WYDALE AVENUE WATER MAIN REPLACEMENT

PLAN AND PROFILE

C7

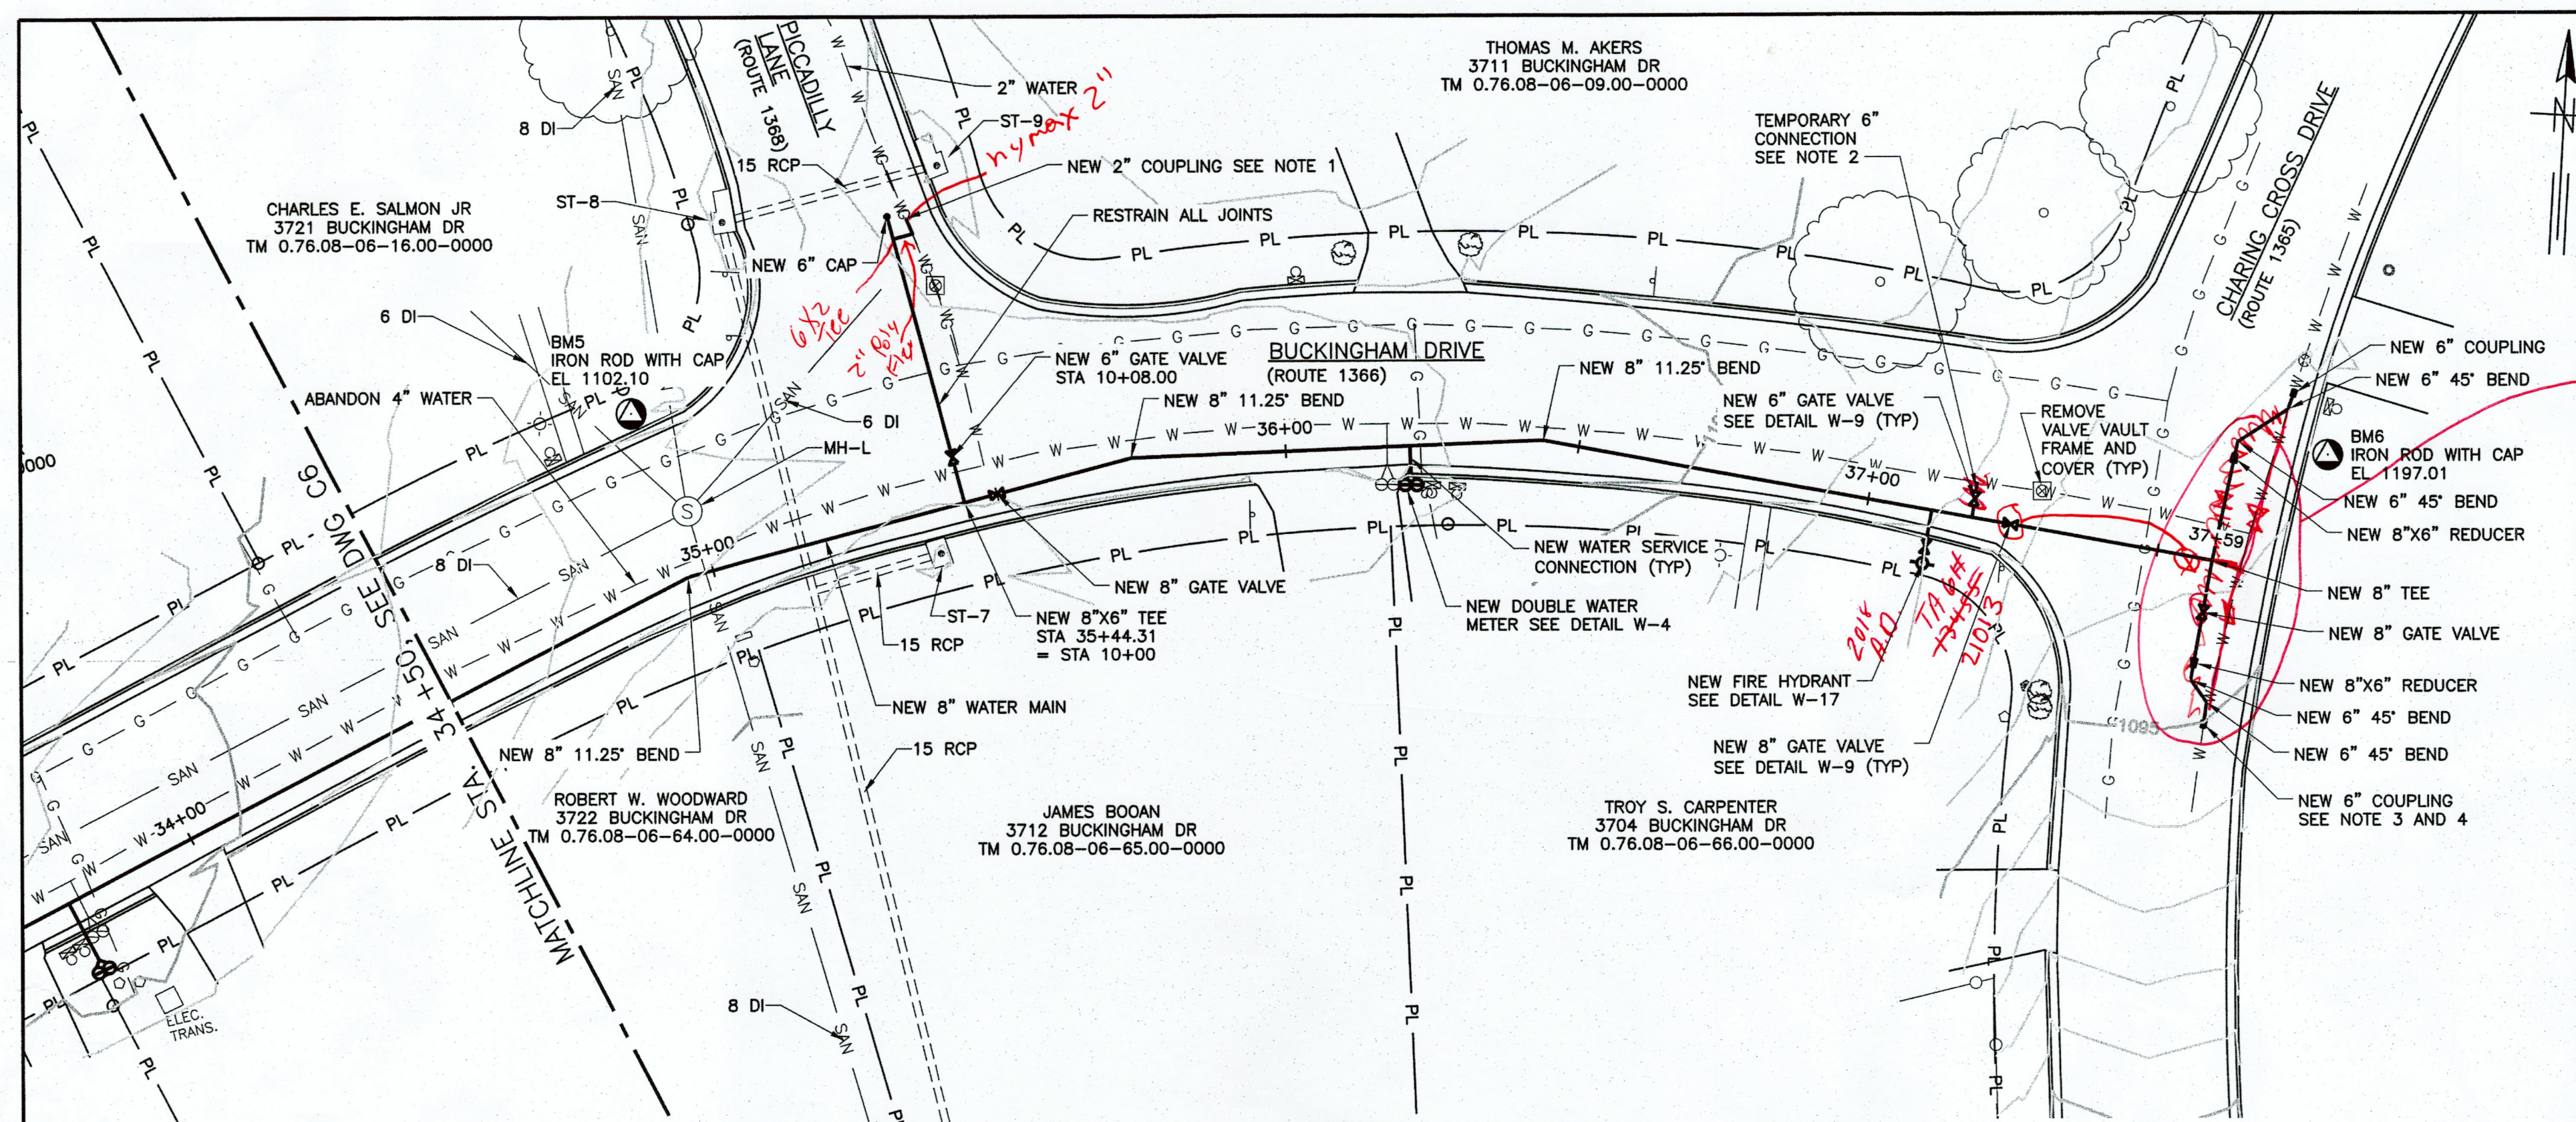
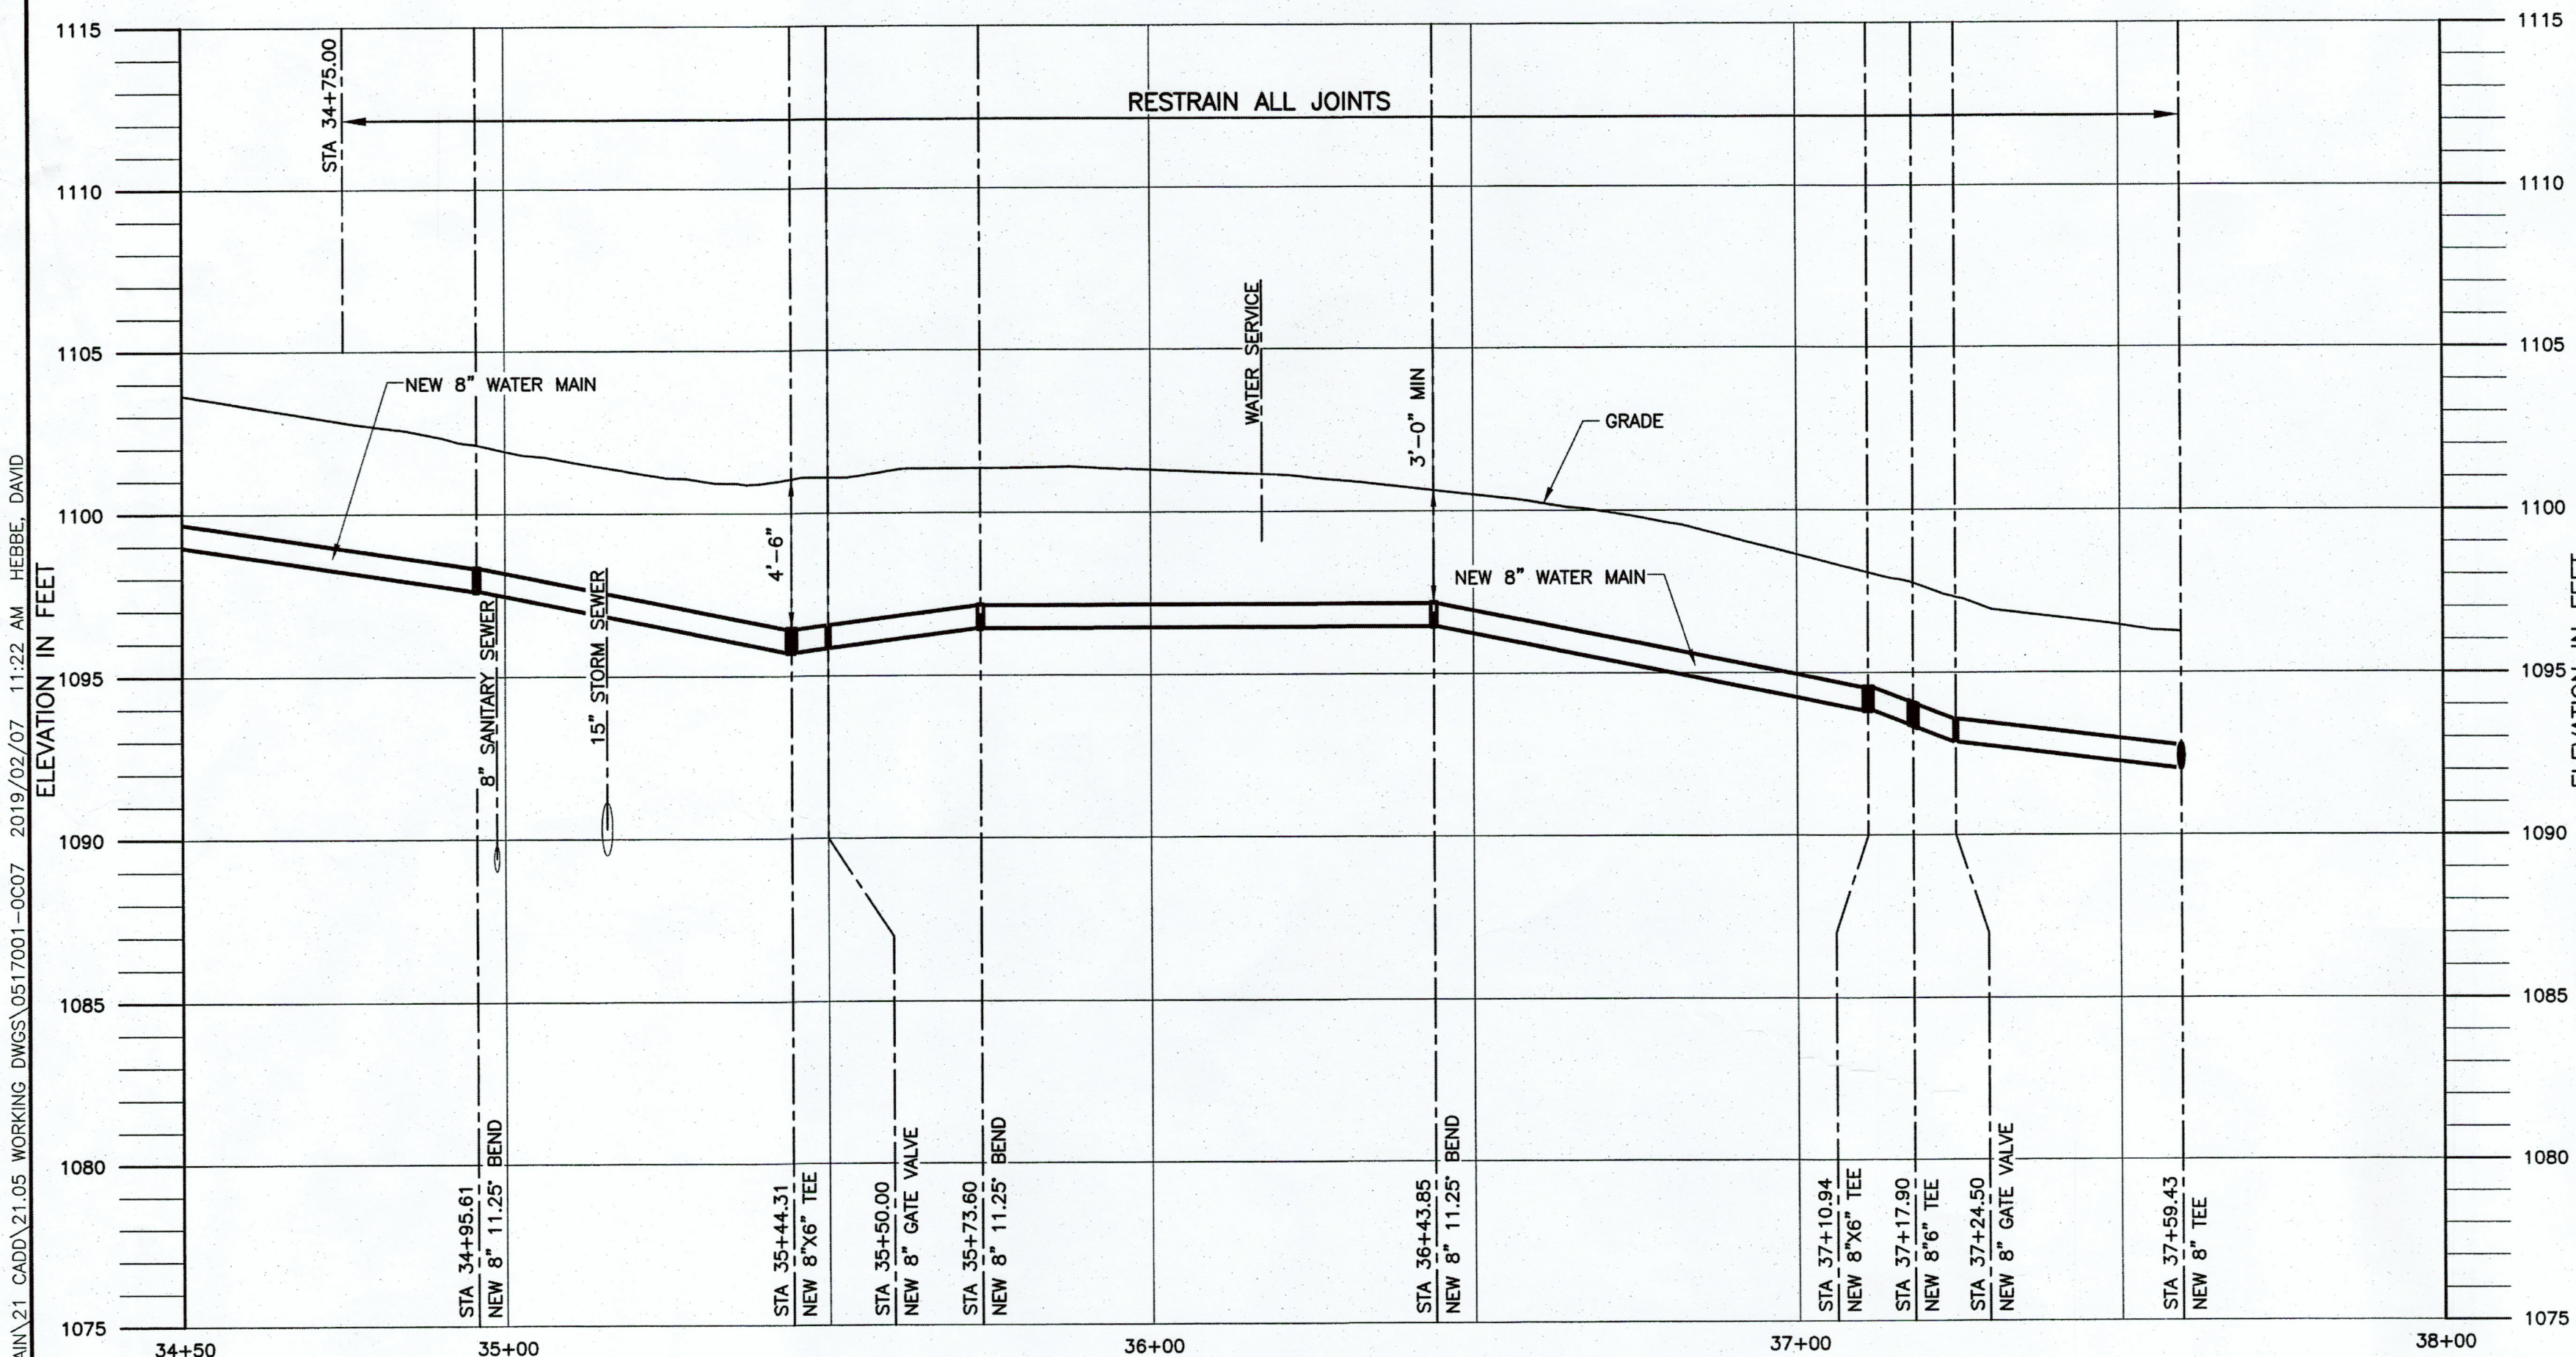
8" Valve
Foster
Adaptor
on Tee

6x8 Reducer
-3"
-Valve 8" AFC
-4"
-8x8 Tee
-3"
-5" Valve AFC
-4"
-6x8 Reducer

* In line with
existing NO 45° Bends
USED. Took out Existing pipe
Installed New pipe SAME place
